SUBJECT: Transmittal of Revised Responses to AP1000 DSER Open Items

AP1000 Design Certification Review Draft Safety Evaluation Report Open Item Non-Proprietary Responses

DSER Open Item Number: ACRS ISSUE 5 Rev 1

Figure 1
Decomposition Even Tree

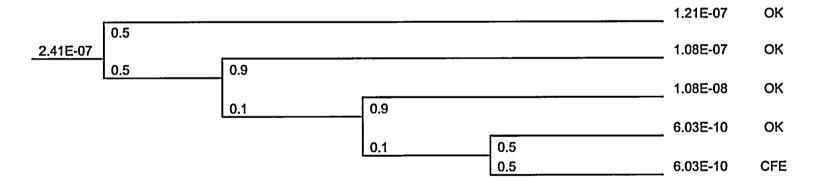
To examine the likelihood of the formation of a bottom metal layer that challenges the lower head integrity can be decomposed into a series of questions and analyzed on a decomposition event tree (Figure 1):

The Decomposition Event Tree is quantified in Figure 1. The base large release frequency from the internal event at power PRA is 2x10⁻⁸ per reactor-year. The increase to the large release frequency from a steam explosion induced by the failure of IVR due to the formation of a bottom metal layer that dissolves the lower head is 6.0x10⁻¹⁰ per reactor-year, or a 3% increase. The conditional containment failure probability increases from 8.1 percent to 8.3 percent. This increase in large release frequency is considered to be negligible and does not impact the results of the PRA.
